D. O. Foster
Vice President and Project
General Manager
Vogtle Project

June 13, 1985

File: X7BG10
Log: GN-639

Reference: 50-424/85-06, 50-425/85-06

FIGURE A

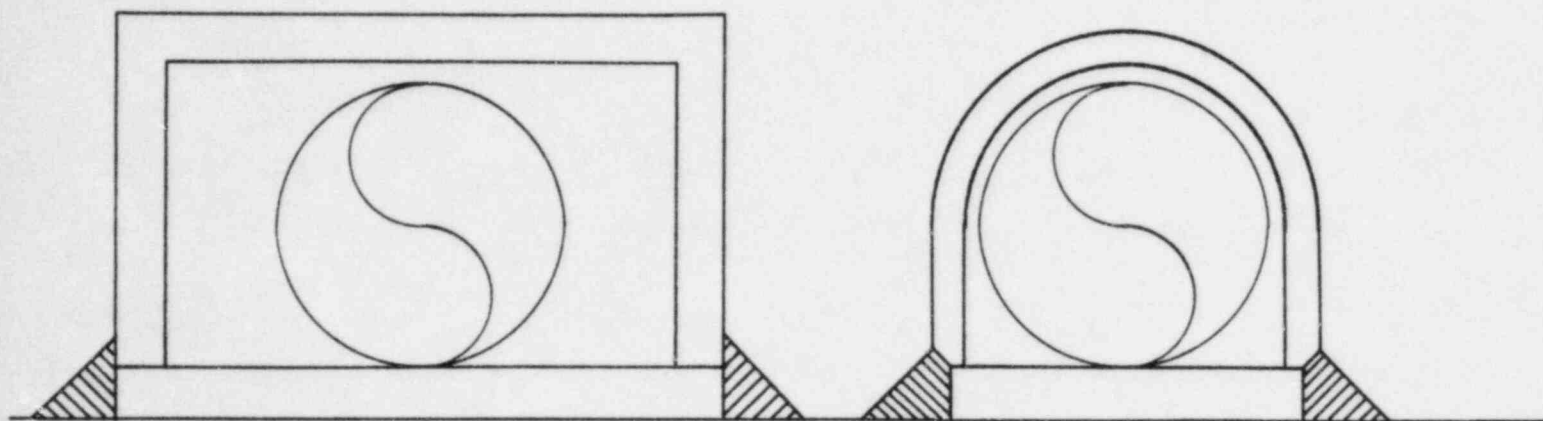
Your letter states that our response of April 16, 1985, does not completely address the violation identified in the NRC inspection report. The NRC Staff Assessment of Licensee Response, attached to your letter, states that some pipe support filler plates and their welds are subjected to tensile and shear forces and, therefore, documentation of filler plate usage is required for as-built review by engineering because the filler plates are load bearing members.

1. Division P5 of Construction specification X4AZ01 restricts the usage of filler plates less than 3/8 inches thick to applications where the pipe strap loads are not transmitted through the filler plate material. In this configuration, shown in attached Figure A, the filler plate is flush with the ends of the strap and the welds transmit the strap loads directly to the support steel. The weld size is increased by the thickness of the filler plate to maintain design strength. The filler plate is exposed only to bearing loads from the pipe; therefore, the filler plate is basically being used as a shim. Additionally, the filler plate ends serve as weld backings. Since this configuration is simply a shimming operation, there is no need to produce as-built records for individual installations for engineering review.

FIGURE B

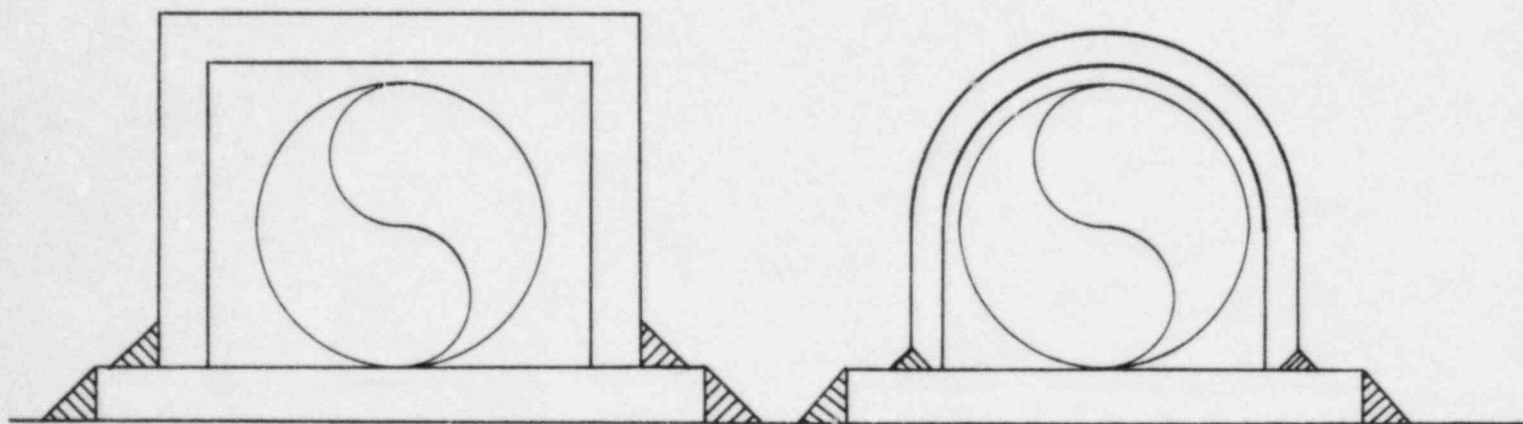
2. Larger filler plates (from 3/8 inch to 1 1/2 inch in thickness) are required to be installed in a different configuration as shown in Figure B. Since these filler plates extend beyond the strap

ends, the filler plate material is subjected to the support loads and is basically a structural element. However, existing engineering calculations substantiate that these thicker materials are stiff enough and have sufficient section to maintain stresses within design requirements when loaded to the maximum strap capacity. Since the filler plate design using this configuration is substantiated by engineering analysis, as-built documentation for engineering evaluation of individual installations is not required.
